***Section 75W Application to Modify the
Minister's Approval for the Barangaroo
Concept Plan***

Major Project 06_0162 (MOD 3)

Director-General's
Environmental Assessment Report
Section 75W of the
*Environmental Planning and
Assessment Act 1979*

October 2009

Figure 4: Revised Headland Park and Northern Cove design (as part of PPR)

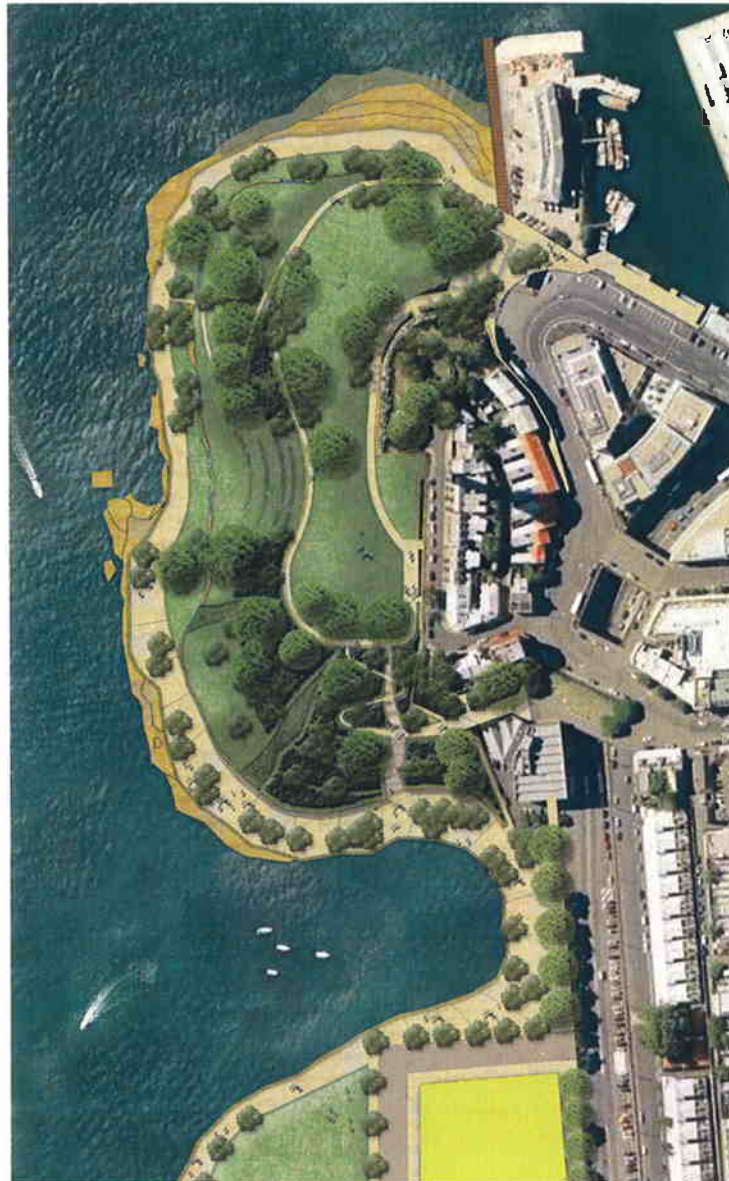
In response to the issues raised during public exhibition as well as the issues raised by the Department, the PPR has made the following amendments to the initial EA:

Headland Park/Northern Cove

- Inclusion of natural shoreline treatment that provides an interpretation of the original landform (refer to **Figure 4**);

- An amended design to address the sandstone cut at its southern end, with the full height of the cut integrated into the design of the car park;
- Further design refinement regarding accessible path locations and circulations;
- A path and steps has been provided that leads to the water in the Northern Cove;
- The inclusion of greater shrub planting areas at the southern end of the Headland Park; and
- The caissons have been retained as part of the terraced shoreline.

The proposed headland has been redesigned to form a more naturalised shape, and the levels of the park have been raised to physically link with Clyne Reserve and Merriman Street to allow direct pedestrian access to/from Argyle place. The naturalised shape has been further accentuated in the PPR when compared to the EA (refer to Figures 3 and 4).

Figure 5: Indicative location of alternative car park access (circled red)

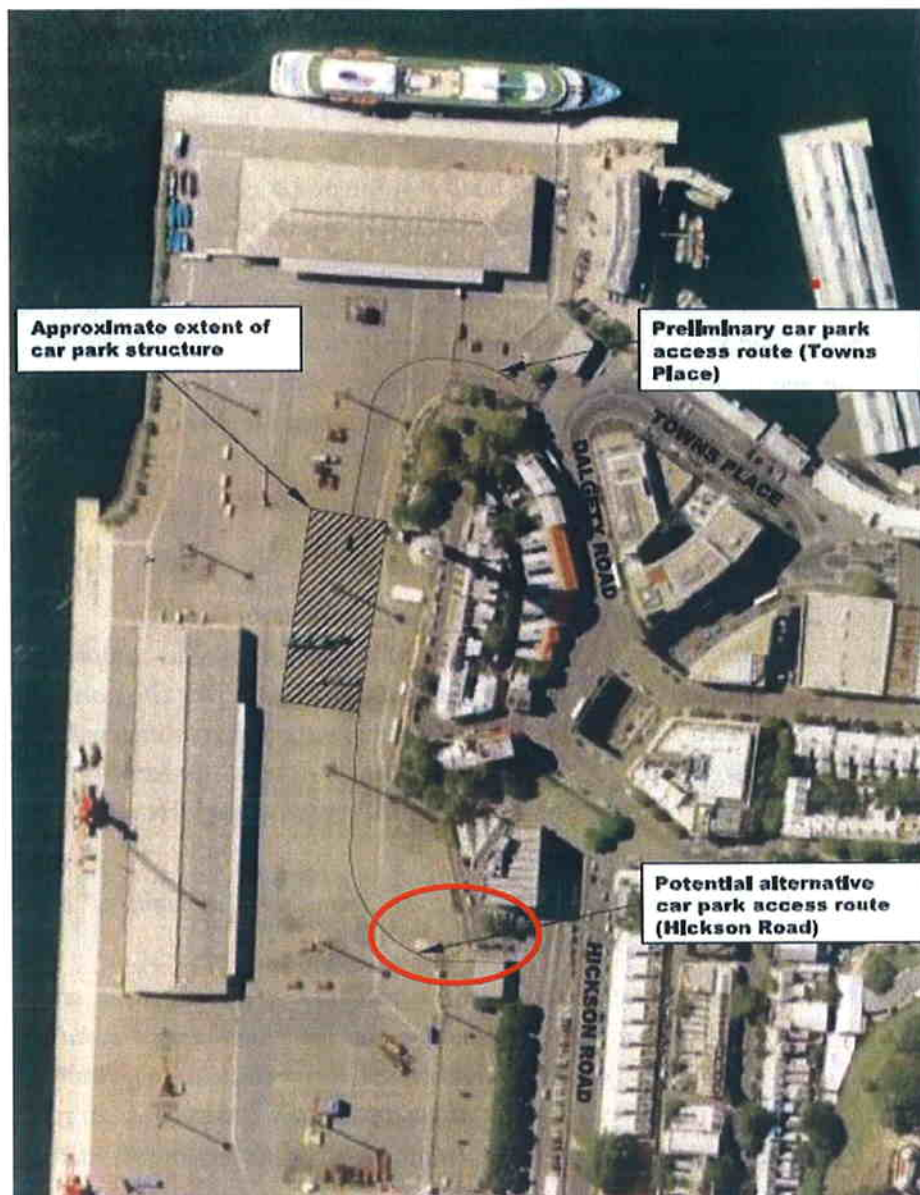
During the public exhibition of the EA, public concerns were raised regarding potential traffic impacts along Dalgety Road and Towns Place resulting from the proposed car park at the northern end of the site, as per the approved Concept Plan. This issue was addressed in the PPR by the proponent indicating they will investigate an alternative vehicular access to the car park via the existing driveway located at Gate D4 on Hickson Road (circled red in **Figure 5**). This will be considered as part of the detailed design of the Headland Park and Northern Cove.

The proposal includes the provision of a concealed car park under the headland park containing 300 spaces. The primary vehicular access route into the car park will be from Towns Place and Dalgety Road, with pedestrian access from both Merriman Street and Dalgety Road. During the public exhibition, concerns were raised by local residents regarding traffic impacts along Towns Place and Dalgety Road due to the car park. In response, the proponent's PPR has included the option of providing an alternate access route into the car park via Hickson Road. This will be investigated as part of the detailed design of the Headland Park and Northern Cove.
